CITY OF NAPOLEON - BUILDING DEPARTMENT
 255 West Riverview Avenue, Napoleon, Ohio 43545 - 419-592-4010

Job Location 130 Wayne Park Drive
address

ADDENDUM TO Permit No. 01396 - (1)
 Owner WILL DURD HAPT
 Contractor BLUE WATER POOLS
 Location 130 WAYNE PARK DR.

IN GRASSY POOL OVAL

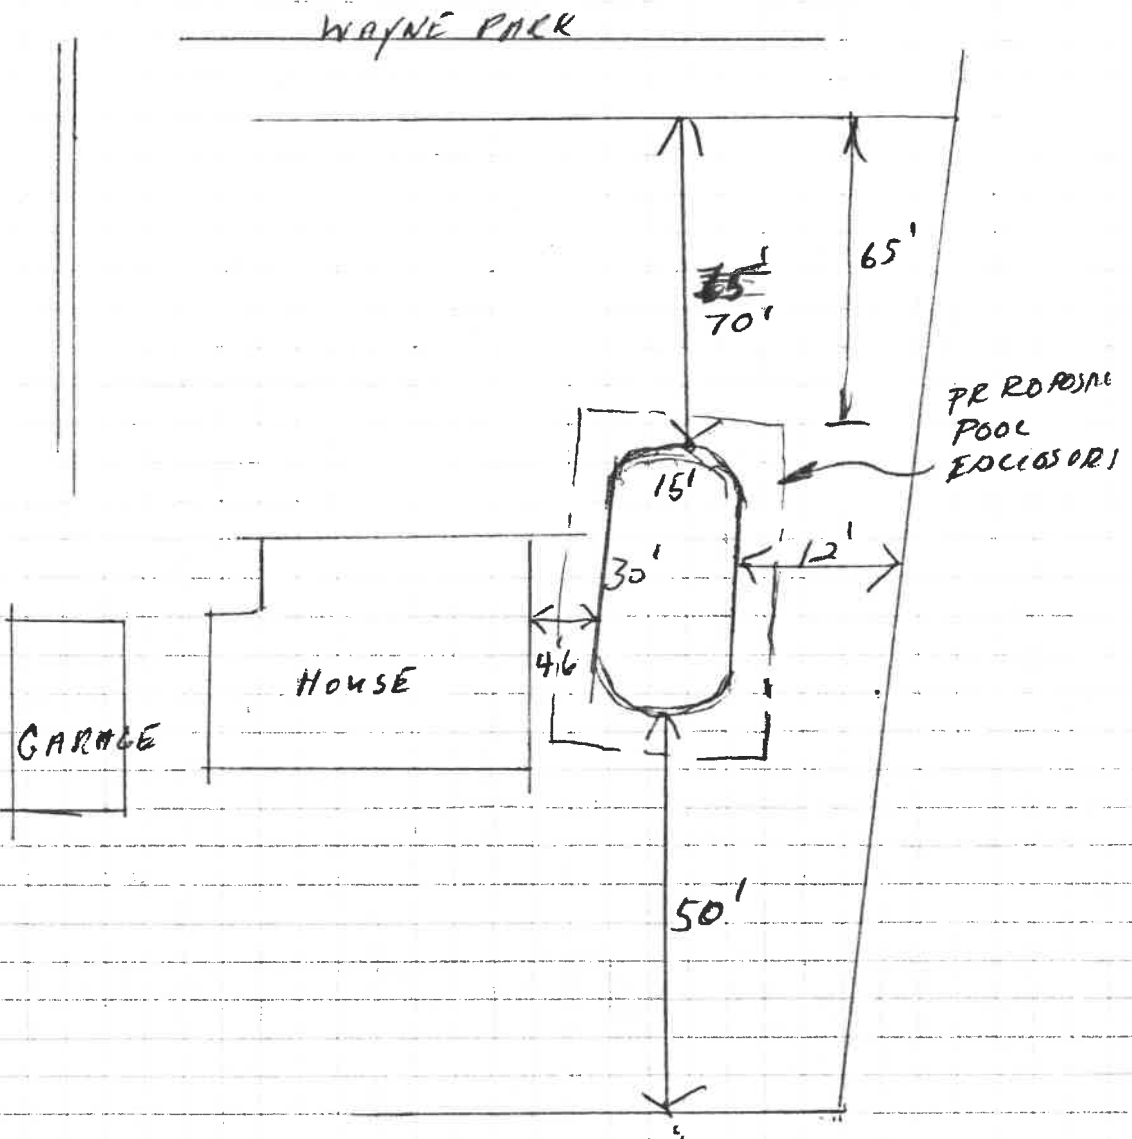
Additional Corrections. PROVIDE A MIN. 4'-0" HIGH FENCE WITH SELF CLOSING GATE AROUND POOL. GROUND ALL METAL PART, PROVIDE G.F.C.I. FOR ALL CIRCUITS. PROVIDE SMOKE DETECTORS AS REQ. IN EXISTING HOUSE.
